ATTACHMENT A

Revise the Technical Specification pages as follows:

## ATTACHMENT B

This safety evaluation addresses proposed revisions to Section 6 of the Ginna Technical Specifications concerning administrative controls. Specifically requested is the deletion of the organization charts from Section 6.2. The NRC has approved a similar change for McGuire Nuclear Station on March 16, 1986.

FIGURE 2-1

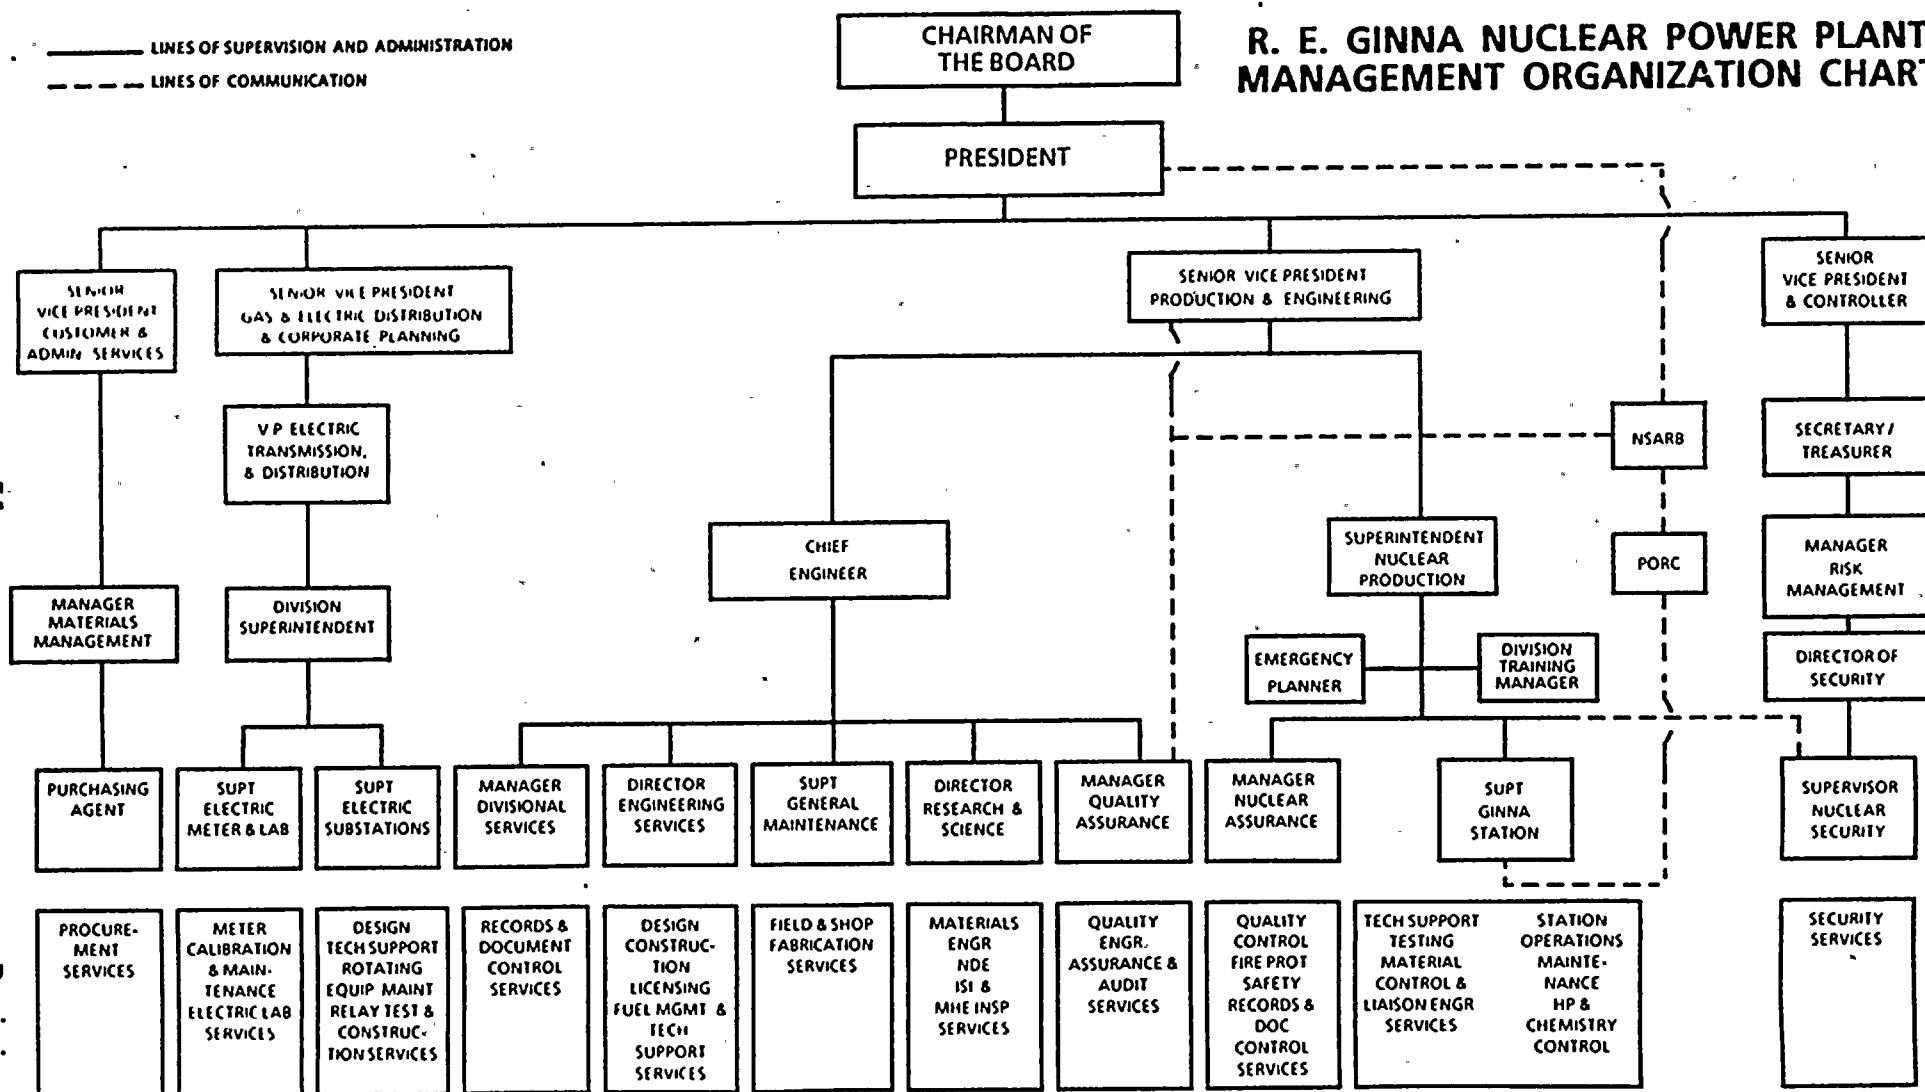
The required content of the administrative controls section of the Technical Specifications is specified in 10CFR50.36c(5). The regulation does not specify that organization charts be included in the Technical Specifications. The proposed revision establishes guidance for the management organizations both onsite and offsite. The specific organization charts will be maintained in Chapter 13 of the UFSAR and the Ginna Station Quality Assurance Manual.

These organization charts will be documented in the UFSAR and updated in accordance with 10CFR50.71.
